# WARRANTY BULLETIN

Wb11-14

SUBJECT: ADDITION OF SEALANT IN THE ENGINE

**COMPARTMENT**

#### **SEALANT BEAD 2**

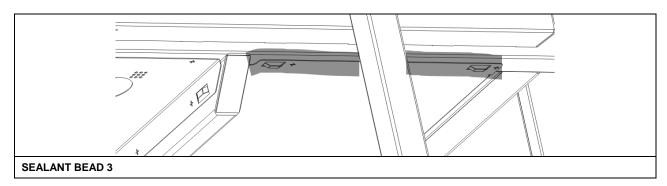
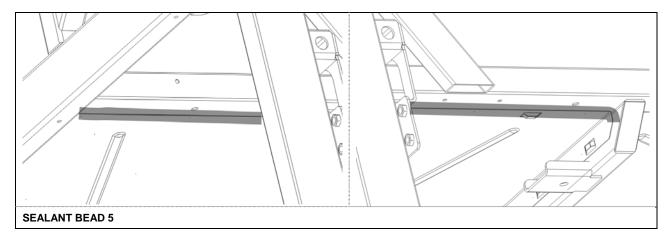
- 1. Using non-greasy solvent like isopropyl alcohol or other type of cleaner currently used in body work shop, clean surface prior to application of sealant in order to assure perfect adhesion.
- 2. Apply Sika 221 sealant at the 5 locations identified on the image below. Apply sealant around the steel sheets shown. The sheets are spot welded on square structural members. Seal the joint between the sheets and the structural members. Once applied, smooth down the sealant bead with a small paint brush. You can find similar sealant beads in the engine compartment to serve as model.
